## In the Drawings

Please accept a sheet including an amended version of Figure 10 introducing the characters A and B as identifying inflection points on the curve of the graph. A second copy showing this change in red is also attached.

### Scope of Figure 6

FIG. 10

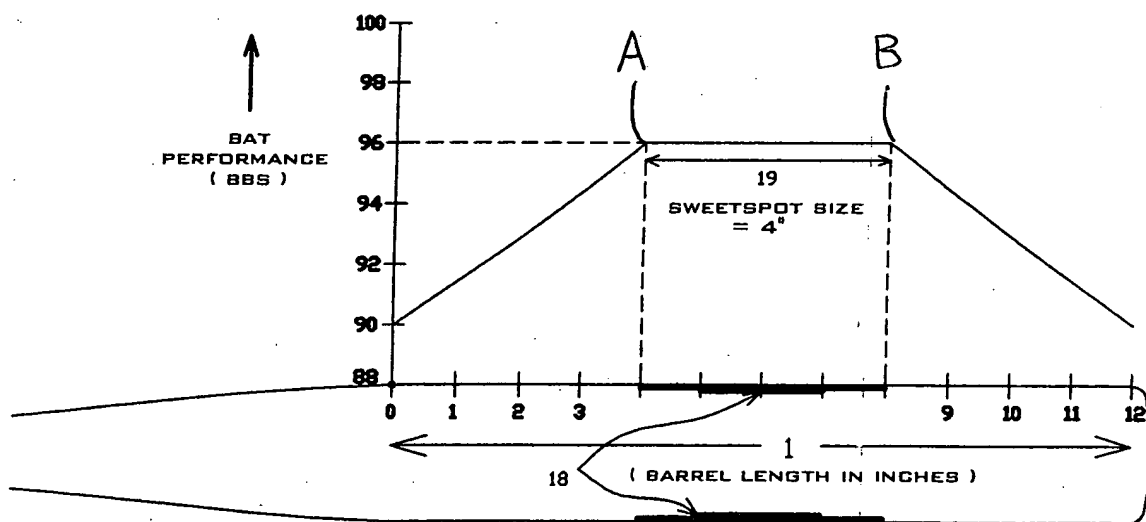
This amendment introduces the points A and B and verbalizes the flattened character of the batting performance curve there between. Such points and curvature were clearly apparent on Figure 10 and have merely been labeled. No new matter is being added.

[0060] In Figure 10, in an example of the present invention, the combined barrel wall, with the polymer composite stiffener 18 present, is approximately twice as stiff in the center 2 inches of the sweet spot area 19 as in the 1 inch area immediately adjacent to the center or mid-section area on each side of the center area. The polymer composite stiffener 18 fiber type, fiber angles and thicknesses are designed such as to reduce the bbs from 100 to 96 in the center 2 inch area of the barrel length 1 and from 98 to 96 bbs in the 1 inch areas immediately adjacent to the center area. As a result of the present invention, the resultant typical example bat meets the lowered regulatory standard of 96 bbs with a sweet spot area 19 which has been increased by 100% (from 2 inch wide to 4 inch wide). **At the same time the regions around points A and B have been introduced into the batting performance curve of Figure 10 that were not present in the curve of Figure 9, with the more flattened portion there-between that is characteristic of an extended sweet spot area 19.**
